## ***Interactive comment on “Hydraulic modelling of drinking water treatment plant operations” by G. I. M. Worm et al.***

Response on review of DWESD 1, 155–172, 2008: DWESD 2, S3–S5, 2009

Fig. 2. (NB. this will be fig 3 in the revised paper). Validation of flows from wells.

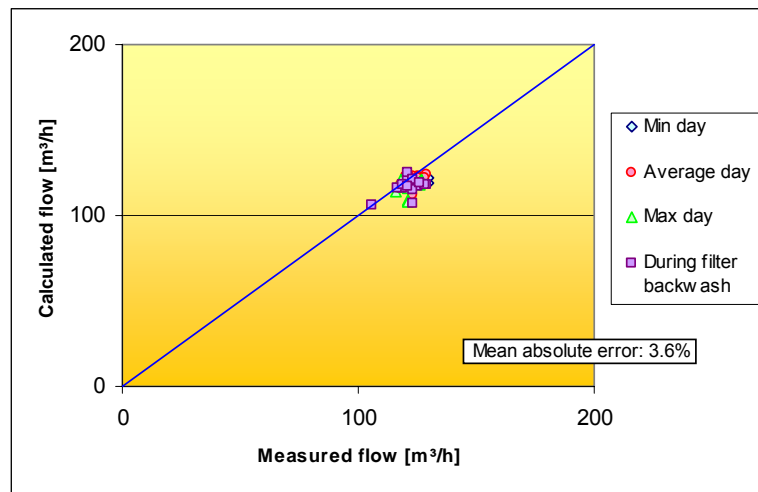
Q: Independently from scale, the plots in Figures 2 and 5 show some obvious deviations. In Figure 2, measured flows from wells are mainly bigger than calculated. On the other hand, in Figure 5 almost all measured effluent flows in the rapid sand filters seem to be smaller than the calculated ones. In fact, only 3 measures are bigger than calculated flows. The updated figures shown in the reply by authors seem to be mistaken, since the three figures are the same.

A: The right, different, figures have been sent to the Publisher in response to the comments of the first referee, but during typesetting one figure was copied three times. Again the three new figures are given below and hopefully will end up in the typ set of this reply. From the reply to referee 1:
